SUP26-0008  
5303 W. Bancroft St.

**TOLEDO - LUCAS COUNTY PLAN COMMISSIONS**

TO: President Vanice S. Williams and Members of Council, City of Toledo  
FROM: Toledo City Plan Commission, Lisa Cottrell, Secretary  
SUBJECT: Special Use Permit Gas & Fuel Sales Station at 5303 W. Bancroft Street  
REF: SUP26-0008

## APPLICATION FOR SPECIAL USE PERMIT FOR GAS & FUEL SALES STATION

**Proposed Site Plan:**

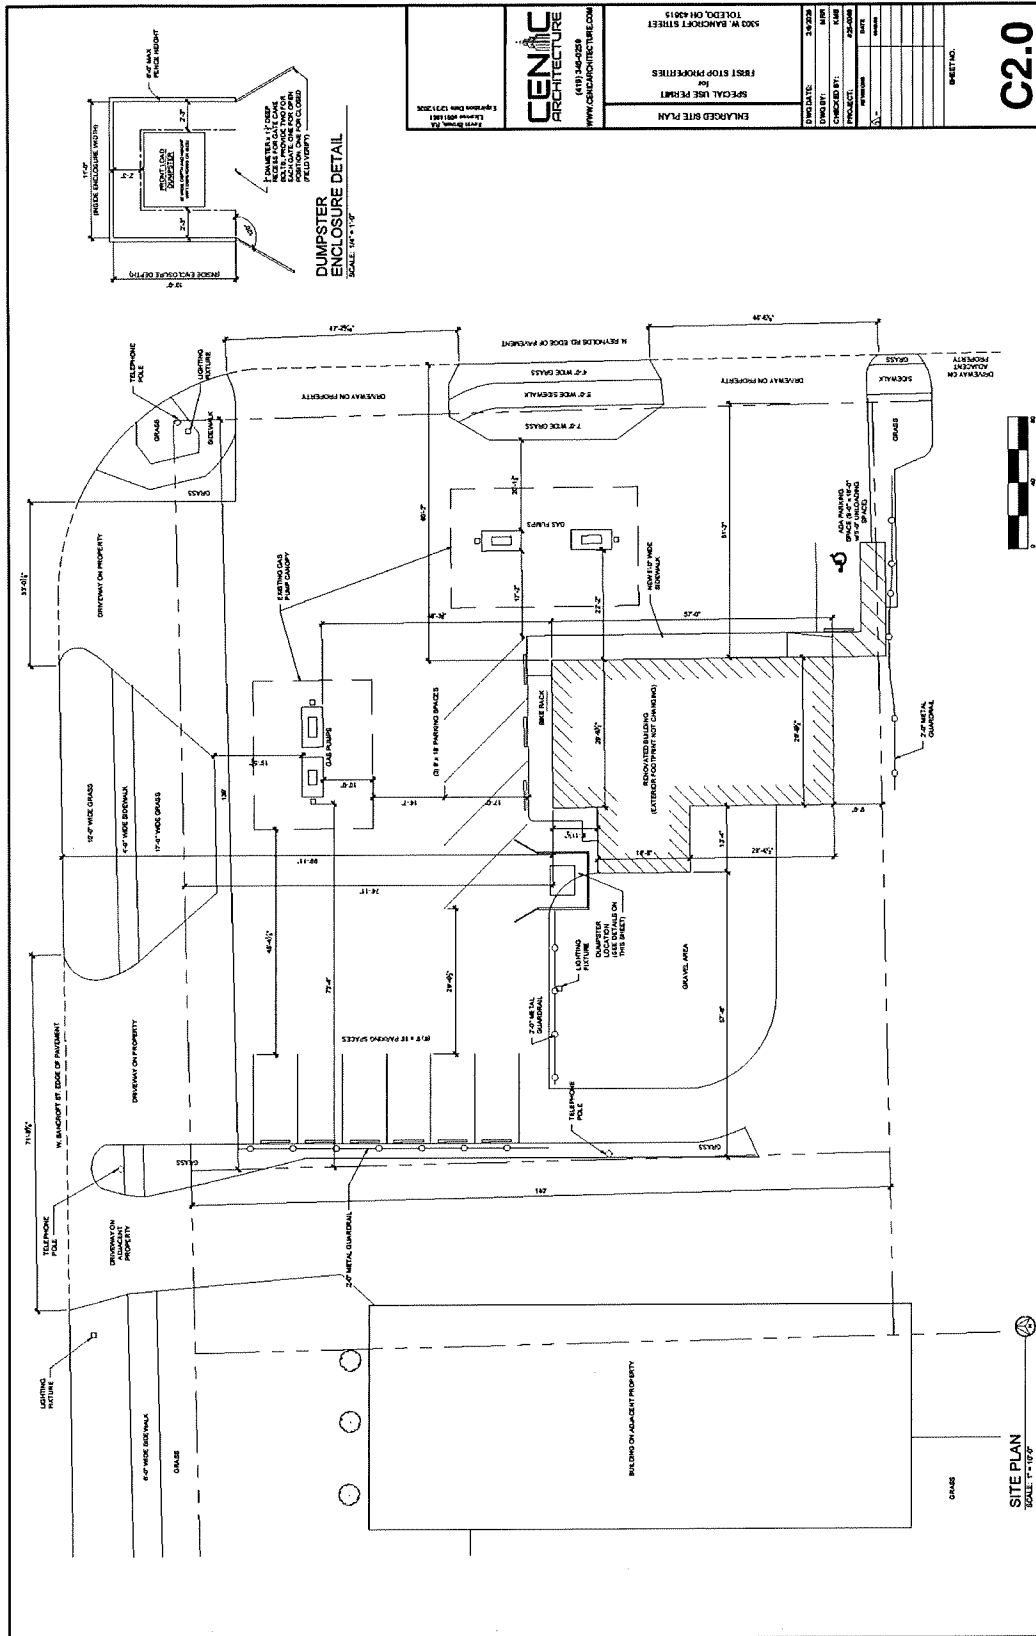
- (a) *Maximum Off-Street Parking.* The maximum number of parking spaces permitted (10) are provided. This is acceptable; however, the stacking spaces at the gas pumps are not shown and the proposed parking layout does not meet parking location and design standards. – Not acceptable

- (b) *Bicycle Parking.* Two (2) bicycle parking slots are required. A bike rack is depicted on the plan; however, it is located on the sidewalk to the north of the building, interfering with pedestrian travel. – Not acceptable

- (c) *ADA Parking.* One (1) van accessible space is required and should be the parking space closest to the building entrance. One (1) auto accessible space is provided, and it is not the closest parking space to the entrance. – Not acceptable

- (d) *Sidewalks.* The Transportation Division is requiring the closure of the access drives on Bancroft Street and Reynolds Road closest to the intersection. Sidewalks shall be provided where these drives are removed to provide a continuous sidewalk along the streets.

- (a) *Dumpster Screening.* Six-foot (6') high screening on all four (4) sides of the dumpster is required. Six-foot (6') high fence with gates is noted on the site plan; however, the fence material and color are not provided. – Not acceptable
- (b) *Guardrails.* Any damaged guardrail along the south and west property lines shall be repaired, removed, and or replaced with an acceptable replacement. The damaged guardrail located in the interior of the site and once used as wheel stop for parking shall be removed.

- (a) *Connecting Walkways.* The main entrance shall face and open directly onto a five-foot (5') wide connecting sidewalk to the street sidewalk and must be distinguished from driving surfaces. A connecting walkway to the entrance is not provided. – Not acceptable

21. Vehicle stacking is required to be shown at each gas pump per TMC§1107.1601.
22. A 25' drive aisle is required between vehicle stacking and the building sidewalk for a two-way drive aisle per TMC§1107.1911.

23. All parking lots, maneuvering areas, drive aisle and driveways must be surfaced with concrete, asphalt or other dust-free material other than gravel or loose fill per TMC§1107.1906. (The gravel at the southwest portion of the property is not permitted.)

24. The driveway in the rear of the building is being closed off by parking and will require the driveway to be removed and new grass to be installed.
25. If one does not already exist, a cross access agreement is required with the property owners to the south and west.
26. The drives on Bancroft Street and Reynolds Road closest to the intersection must be removed. New grass and curb will need to be installed to match adjacent areas.

27. Should charging stations for electric vehicles be provided, they shall meet the requirements of TMC§1105.1300.
28. The maximum number of parking spaces permitted (10) are provided. This is acceptable; however, the stacking spaces at the gas pumps are not shown on the site plan and the proposed parking layout does not meet parking location and design standards. The site plan shall be revised to meet the requirements of TMC§1107.

29. Two (2) bicycle parking slots are required. A bike rack is depicted on the plan; however, it is located on the sidewalk to the north of the building. The site plan shall be revised, relocating the bike rack to a location that will not interfere with pedestrian travel.

30. One (1) van accessible space is required and should be the parking space closest to the building entrance. One (1) auto accessible space is provided, and it is not the closest parking space to the entrance. The site plan shall be revised to include a van accessible parking space nearest to the building entrance with required ADA signage.

31. Sidewalks shall be provided where the Division of Transportation is requiring closure of access drives in Condition 20, to provide a continuous sidewalk along Bancroft Street and Reynolds Road.

34. At least one (1) main entrance of the building shall face and open directly onto a 5-foot (5') wide connecting walkway to the street sidewalk per TMC1109.0204(A). A connecting walkway from Reynolds Road to the building entrance shall be provided.
